UNITED STATES PATENT AND TRADEMARK OFFICE

APPLICATION NO.	FILING DATE	FIRST NAMED INVENTOR	ATTORNEY DOCKET NO.	CONFIRMATION NO.
10/662,500	09/15/2003	Nathaniel Bair	67102-013	9191

Office Action Summary	Application No.	Applicant(s)	
	10/662,500	BAIR, NATHANIEL	
	Examiner	Art Unit	
	Courtney Thomas	2882

DETAILED ACTION

Fig.4 – X-ray scanner – WO 9917659 to Virta et al.

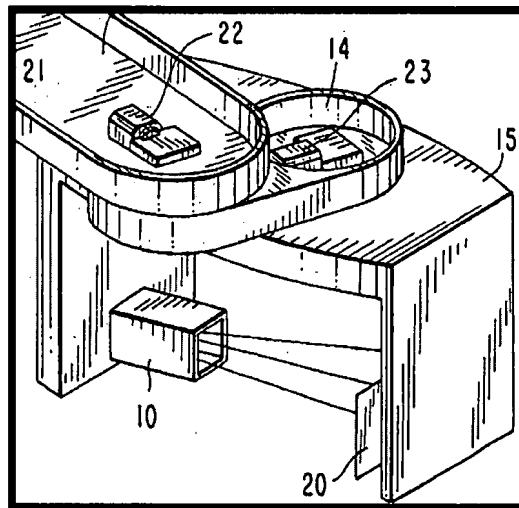
6. As per claims 1, 25, 33 and 34-39, Virta et al. disclose a computed tomography scanner (and corresponding method) comprising: a gantry (15); an X-ray source (10) mounted to the gantry; an X-ray detector (20) mounted to the gantry opposite the X-ray source (10); and a motor (23) mounted to the gantry. [Examiner note: see Figs. and respective portions of specification for additional apparatus details and methodology not shown above].

7. As per claim 2, Virta et al. disclose a computed tomography scanner comprising a mounting plate (14).

8. As per claims 12 and 13, Virta et al. disclose a computed tomography scanner wherein the gantry includes a housing in which the X-ray source (10) is at least partially mounted and wherein the source is a cone beam X-ray source (see Fig. 4 above).

Fig. 3 – X-ray scanner – U.S. Patent Application Publication 2001/0021244 to Suzuki et al.

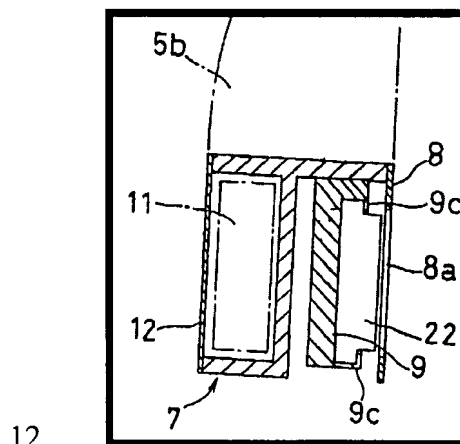
13. Suzuki et al. disclose a scanner including a computer (11) mounted on a gantry (5) such that the computer (11) rotates with the gantry (5) and sends signals the motor to control rotation of the gantry (para. [0098] - 11m - not shown above); controls the X-ray source (11d- not shown above) and processes images collected from the detector (11e – not shown above). Suzuki et al. teach that such construction provides a means of operating a scanner via the gantry.

16. Suzuki et al. disclose a scanner including a computer (11) mounted on a gantry (5) such that the computer (11) rotates with the gantry (5).
